Notice of Meeting of the Historic and Architectural Review Commission of the City of Georgetown, Texas April 23, 2026

509 S Myrtle Street, (2025-51-COA)

509 S Myrtle Street 2025-51-COA

Planning Department Staff Report

Plans and Specifications – Site Plan

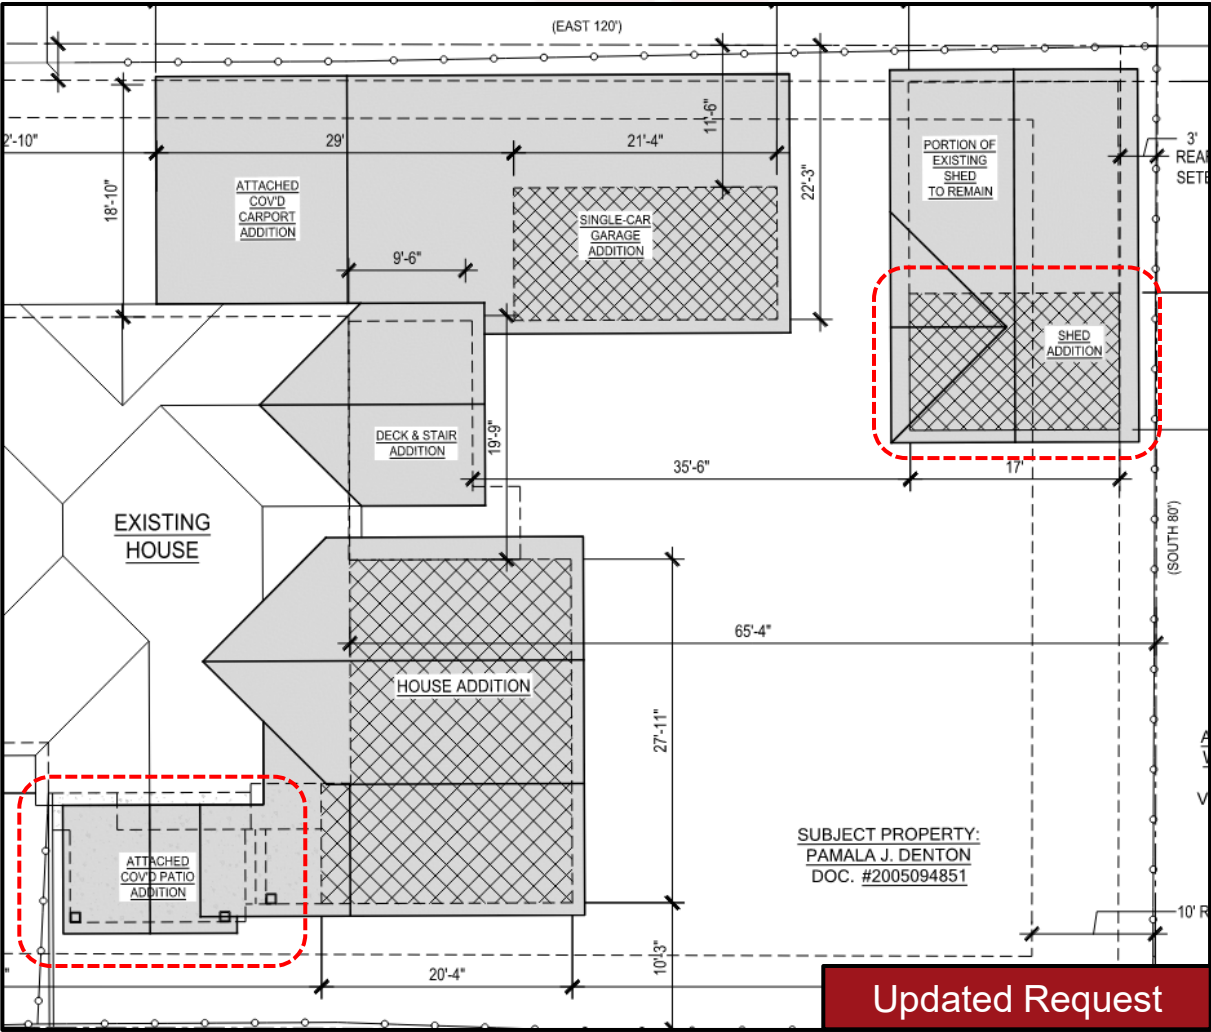
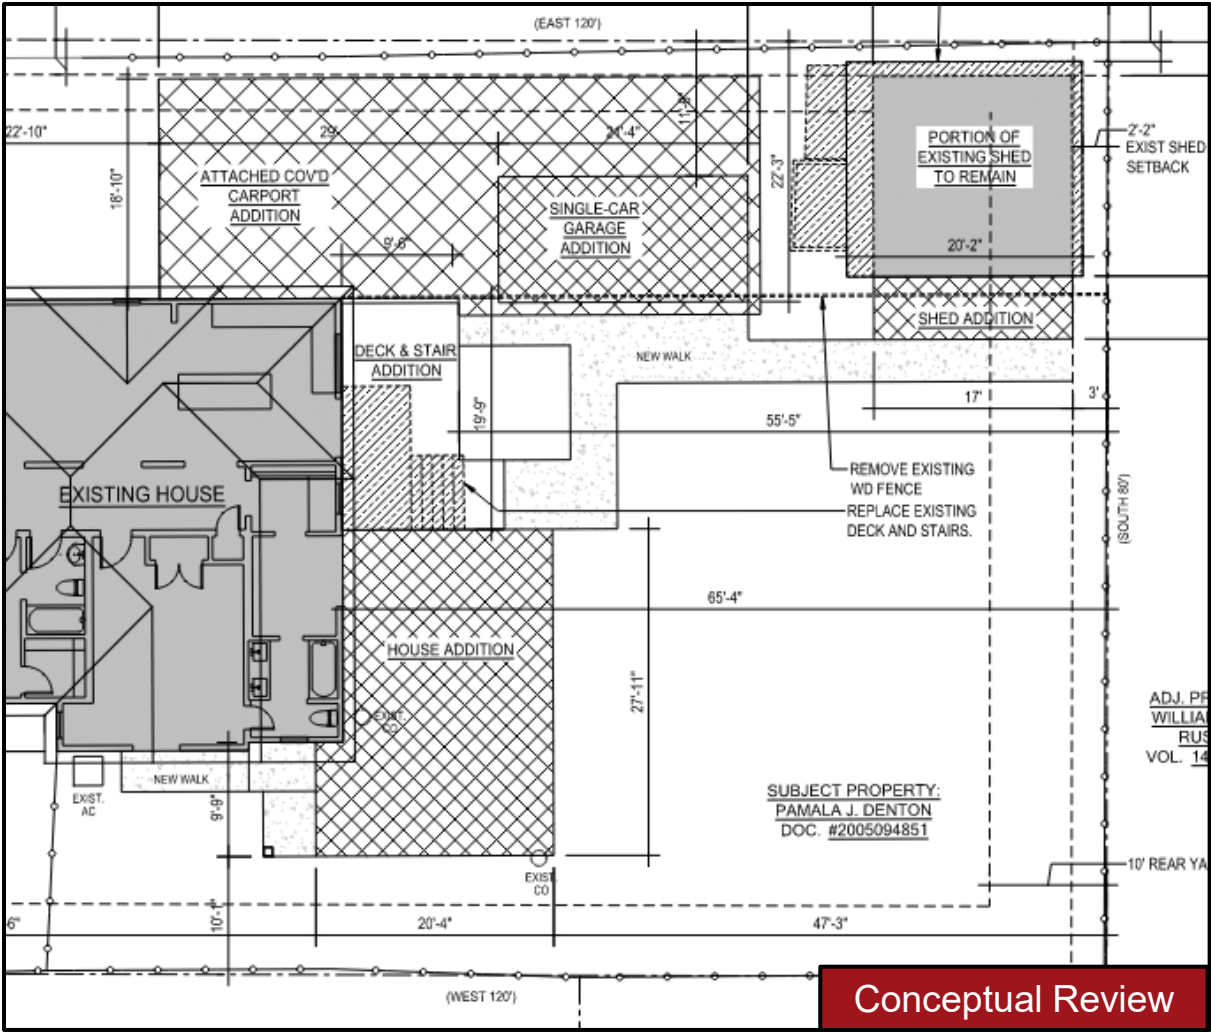
The existing shed is currently located 1'-8" from the side property boundary, and 2'-2" from the rear property boundary. The proposed shed will lessen the setback encroachment and is proposed at 3" from both the side and rear property lines.

- The shed should either be completely demolished and rebuilt somewhere else on the property outside of the required setbacks or if the shed is kept as a single story, then the setback modifications are more appropriate.

- Carport setback as presented is less of a concern since the carport height is low and is open-air within the required setback.
- The setback of both additions from the front façade of the existing house alleviate concerns of differentiating the additions from the original structure.

01 proposed - side (north) elevation

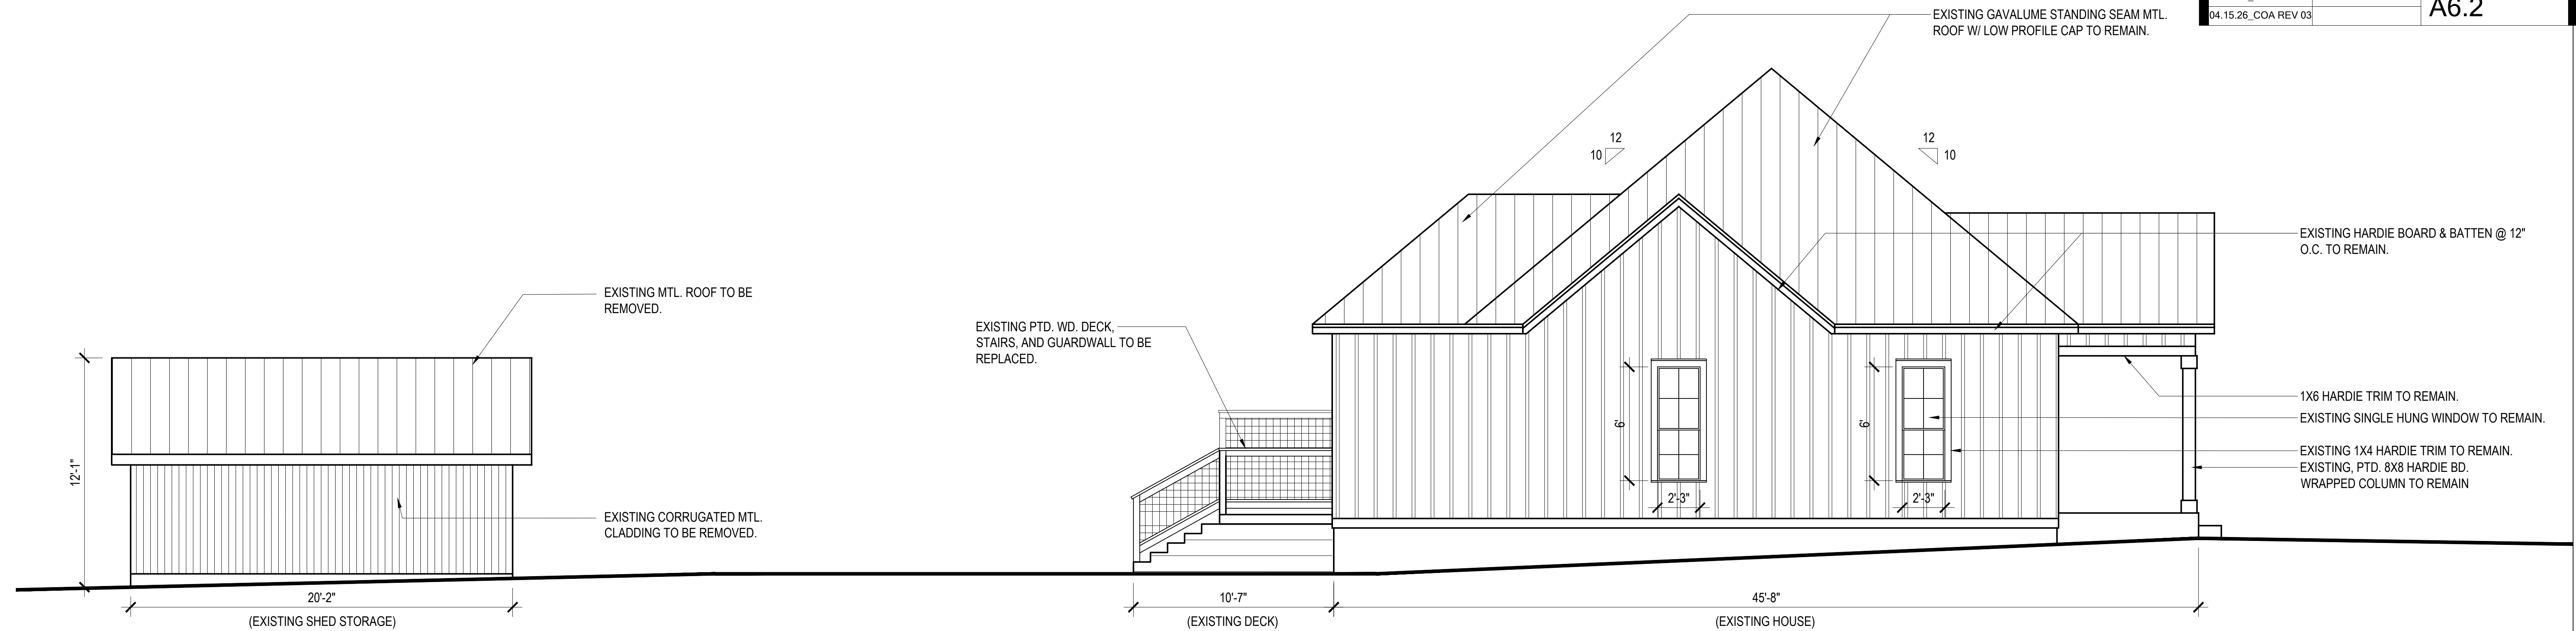
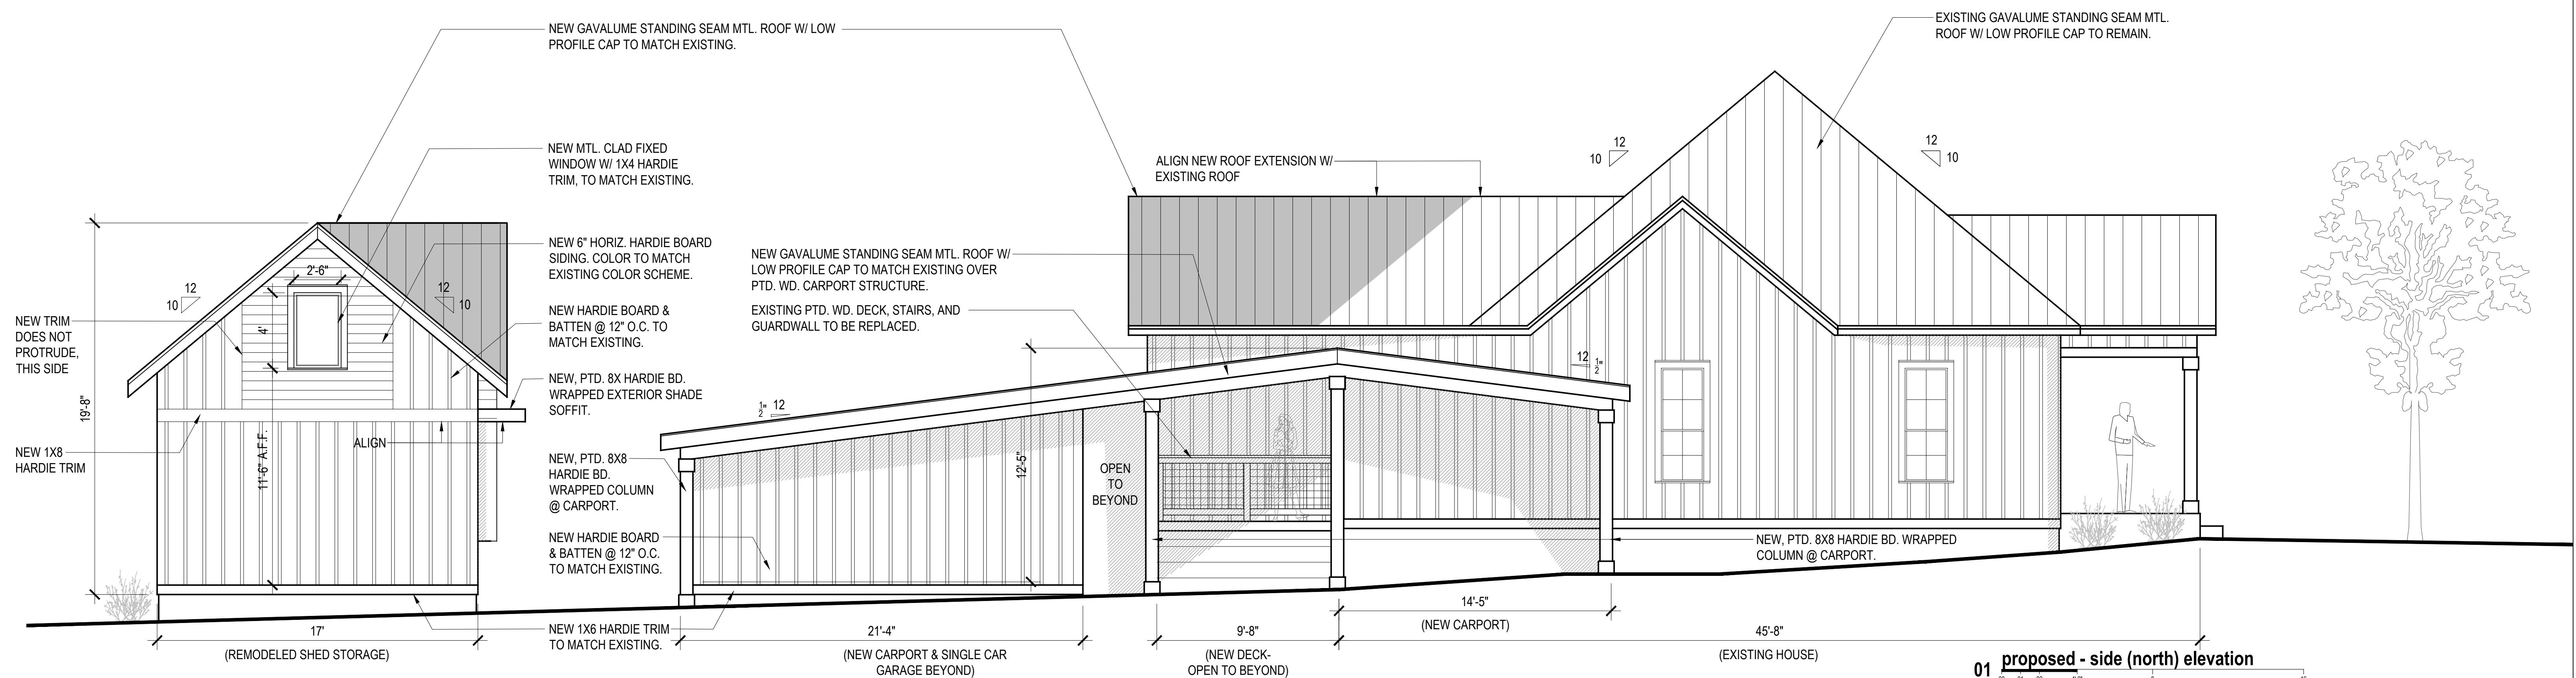
Overall, the request generally complies with the Design Guidelines, however the north façade of the accessory structure reaches 21 feet in height at the peak of the gabled roof. This is a substantial change from the existing 12-foot-tall shed. Further, the existing north façade of the shed reaches 7 feet in height. The remaining 5 feet in height comes from the roof which slopes away from the property line.

g. If the proposed encroachment is for a structure that is replacing another structure, whether the proposed structure is significantly larger than the original;	Does Not Comply The footprint of the proposed accessory structure is moderately larger than the existing shed. The existing shed is 369 square feet, and the updated shed is 482 square feet. Notably, the new square footage is being added towards the interior of the subject property. However, the height of the new shed will be 21' from the ground to the highest point of the roof. Further, since the north façade is gabled, this creates a 21 foot wall 3 feet away from the neighboring property to the north. The shed as it currently exists is 12' from the ground to the highest point of the roof. Additionally, the current shed has a gable the is oriented in a west-east direction so as the shed increases in height, it is also moving away from the north property line.
